Subject: Duke Energy Carolinas, LLC  
William States Lee III Nuclear Station - Docket Nos. 52-018 and 52-019  
AP1000 Combined License Application for the  
William States Lee III Nuclear Station Units 1 and 2  
Response to Request for Additional Information  
Ltr# WLG2008.10-07

Reference: Letter from J.M. Muir (NRC) to B.J. Dolan (Duke Energy), *Request for Additional Information Regarding the Environmental Review of the Combined License Application for William States Lee III Nuclear Station Units 1 and 2*, dated August 21, 2008

**Lee Nuclear Station Response to Request for Additional Information (RAI)**

**Duke Power Company, Project 81, "Cherokee Nuclear  
Station, Earthwork and Drainage Grading Plan," Area South  
of Powerhouse, CK-0021-02 (NW&SWQ), June 3, 1976.**

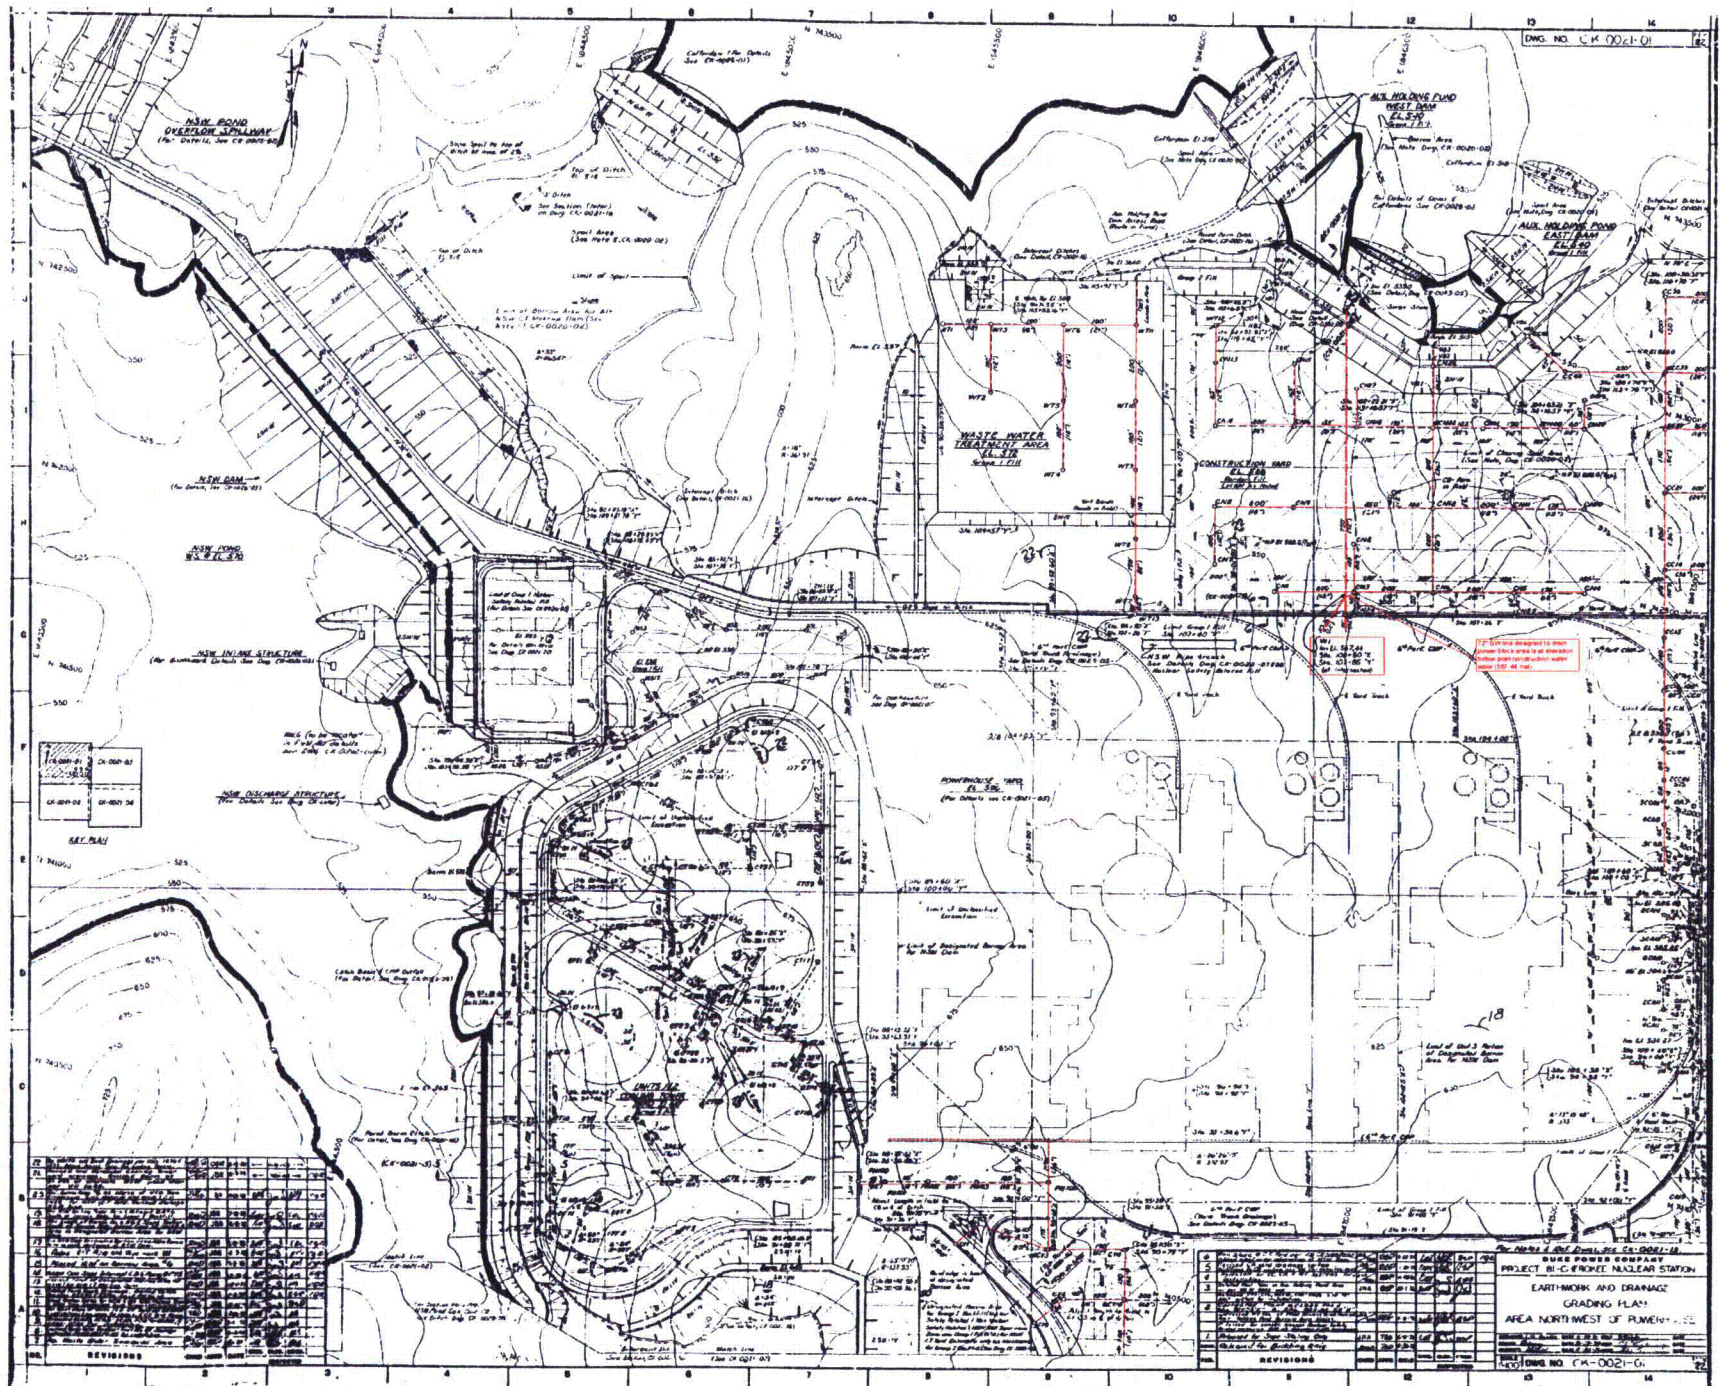
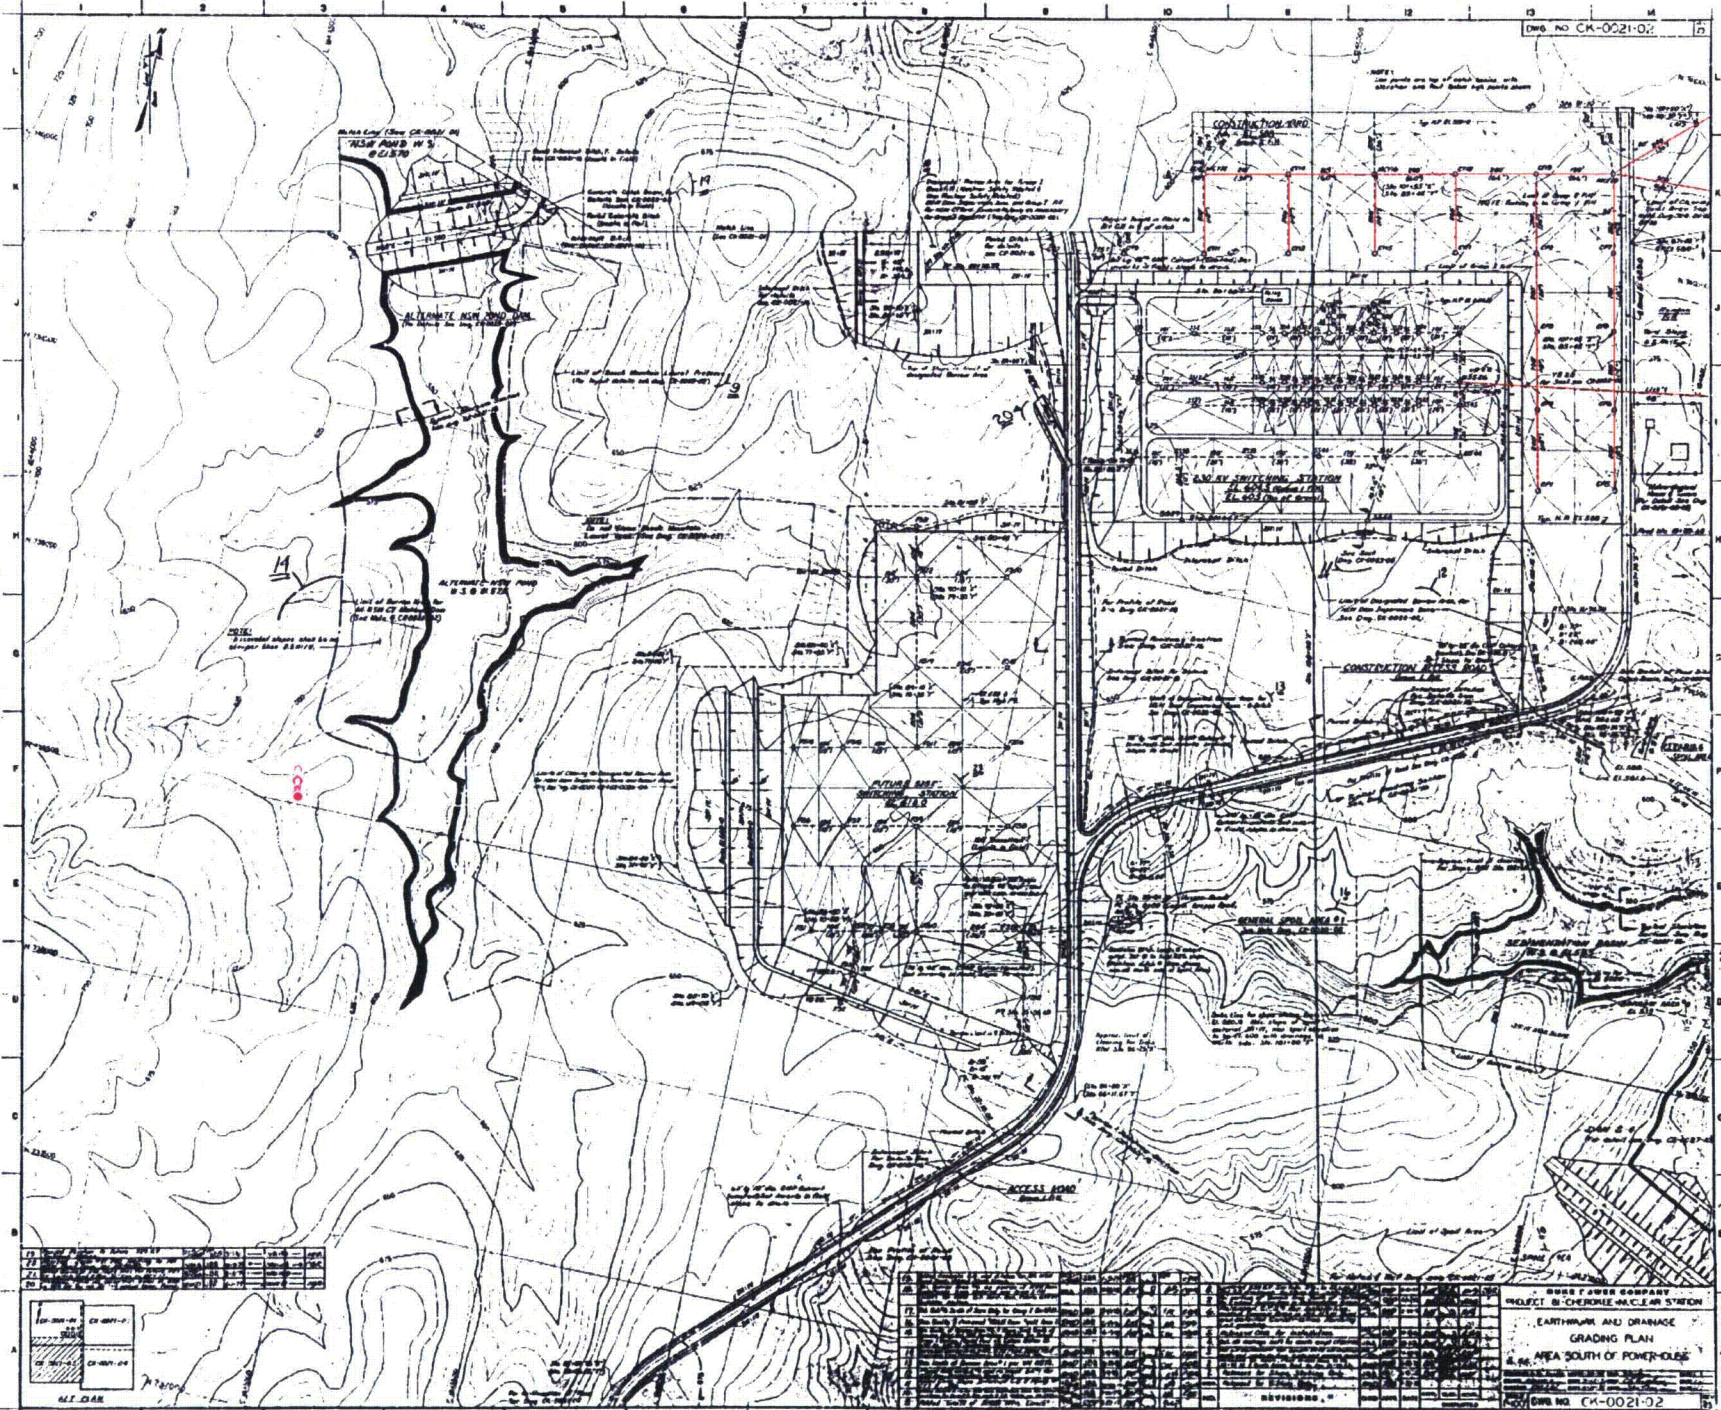
Submit a discussion (and possibly a figure) of prior storm water control structures, such as underground drains and their bedding materials – to clarify their potential to create preferential surface and subsurface flow paths.

The piping corridor that runs from the power block area to Hold-Up Pond A is the only identified Cherokee Nuclear Station stormwater drain piping segment that both intercepts the water table and is in an area downgradient from a potential radioactive source area. The groundwater gradient is relatively steep, and if the hydraulic conductivity of the bedding material is greater than the surrounding materials, the potential exists for this to act as a preferential pathway. A portion of the Cherokee stormwater system plan is shown on the attached figure. Duke Energy expects to mitigate the condition by removing the pipeline or installing engineering controls.

Based on site observations, a network of storm drains and buried piping was partially installed during construction of Cherokee Units 1, 2, and 3 to manage surface water runoff. While no as-built drawings for the existing storm drain system for the former Cherokee Nuclear Station exist, a review of stormwater plans was conducted to assess the drain system's potential effect on groundwater movement. Storm drains located upgradient (south) of the excavation appear to intercept a high water table and may allow movement of water through the annular fill material towards the make-up ponds. In effect, these upgradient storm drains may serve to divert groundwater away from the plant area. Most of the other identified storm drains appear to be above the rebounded water level and would not affect the movement of groundwater. One exception is a downgradient (north) storm drain line designed to transfer stormwater from the Cherokee power block area to Hold-Up Pond A. The depth of this storm drain pipe appears to be

**FSAR Figure 2.4.12-208 (new)**

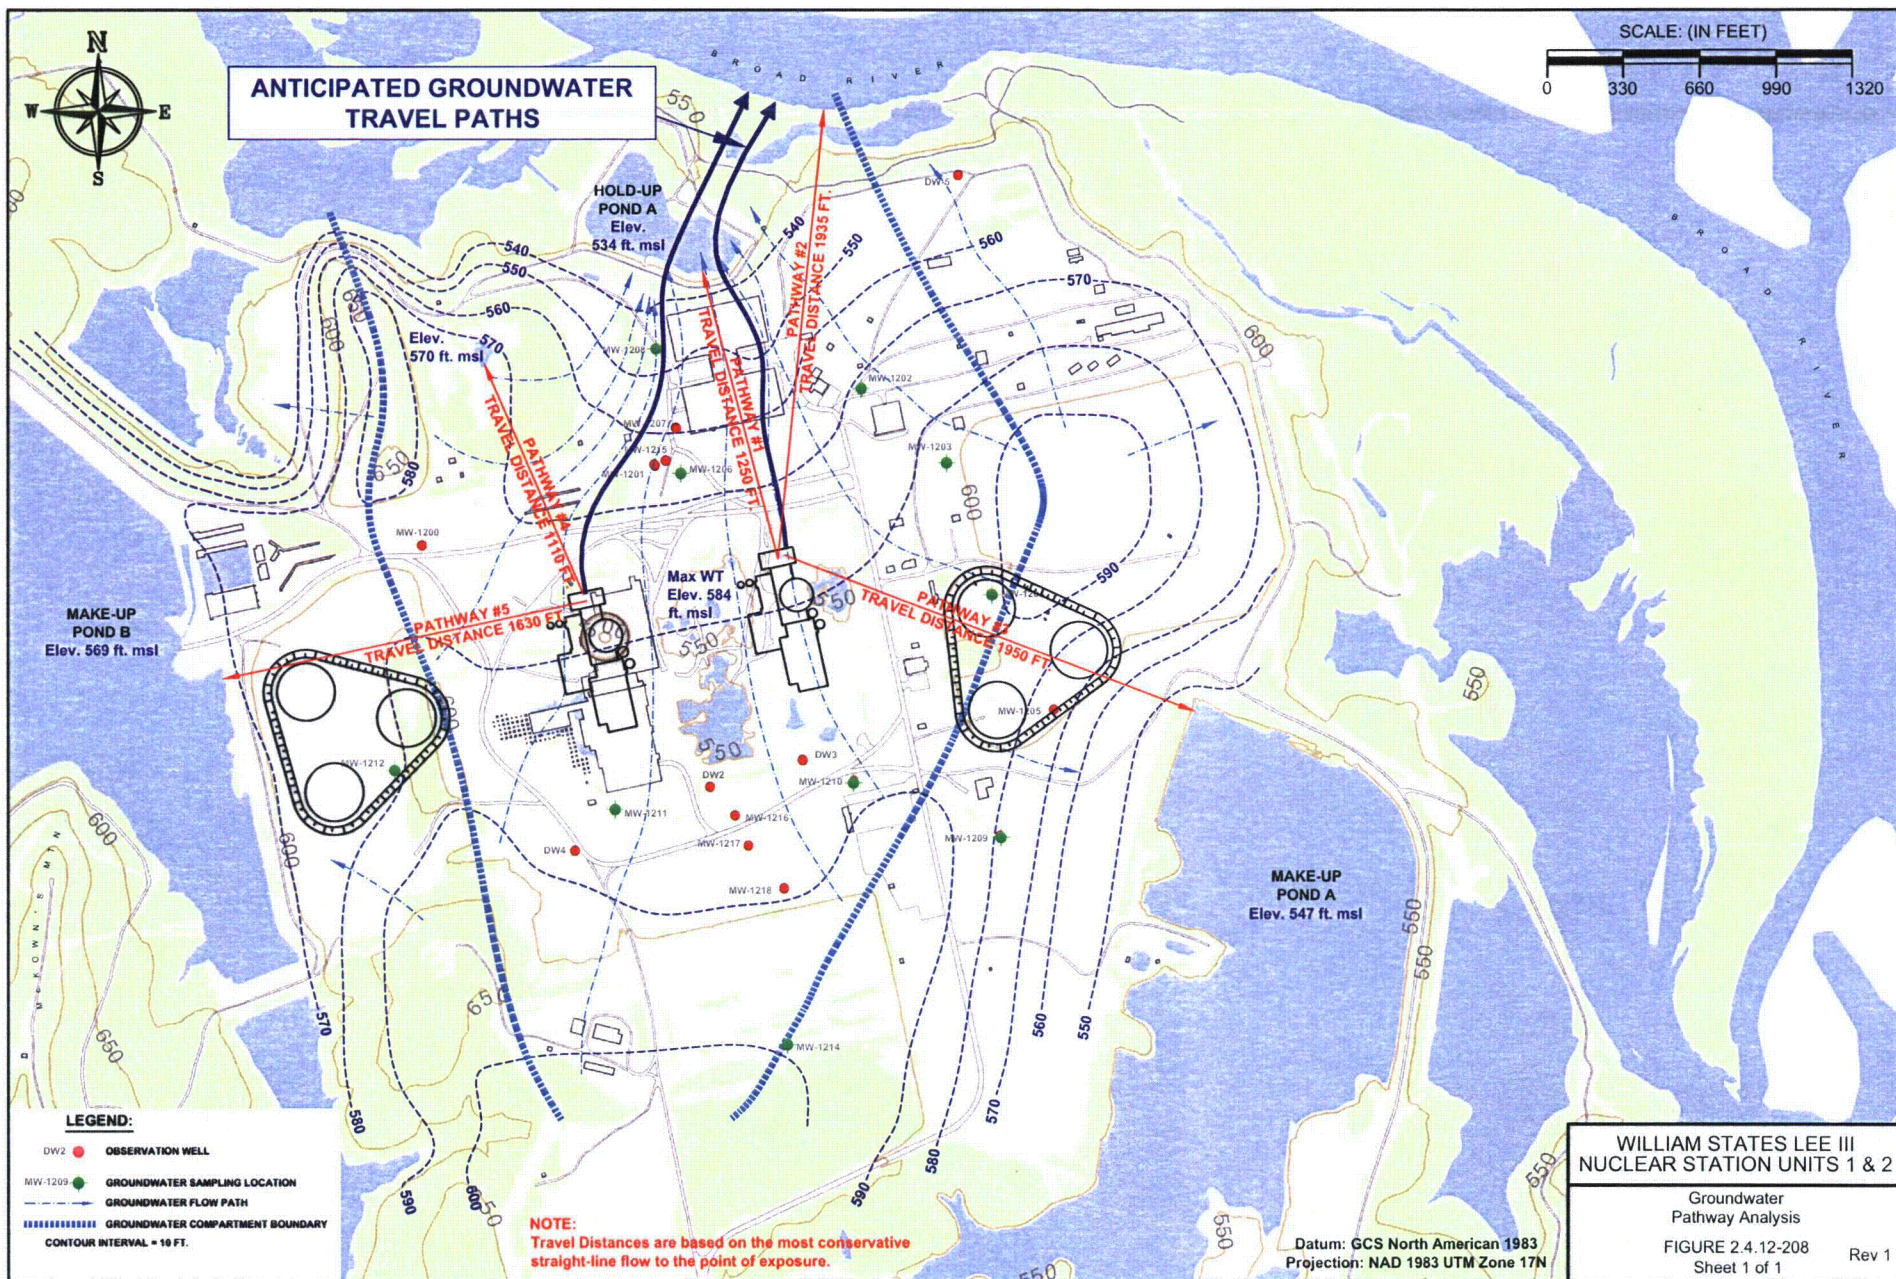
These pathways are represented on FSAR Figure 2.4.12-208. The results of the analysis identified the conservative flow path for a postulated release to be from the Unit 2 radwaste storage tank to the Broad River (Pathway 2, Figure 2.3-16, Sheet 3).

The response to this RAI is described below in the revised ER text and addition of the attached new FSAR figure (Attachment 7-1).

After construction dewatering and the return to static conditions, the potentiometric surface beneath the reactor buildings is expected to rebound to a maximum elevation of approximately 584 ft. above msl, the maximum anticipated groundwater level during operations. Based on the preceding discussion of hydraulic conductivity (Subsection 2.3.1.5.8), effective porosity (Subsection 2.3.1.5.3), hydraulic gradients (derived from Figure 2.3-15, Sheet 8), and groundwater velocities were determined for multiple flow paths. For example, one projected groundwater flow path (Pathway 1) is to the north from the Unit 2 reactor building to Hold-Up Pond A, with an average projected gradient of approximately 0.040 ft/ft and a distance to a potential exposure point of 1250 ft., which is the shortest of the flow paths evaluated. Another flow path (Pathway 2) from the Unit 2 reactor building to the Broad River, through partially weathered rock, had a faster travel time to the point of exposure because of greater hydraulic conductivity, even though it has a greater distance of 1935 ft. These two pathways are shown in Table 2.3-6.
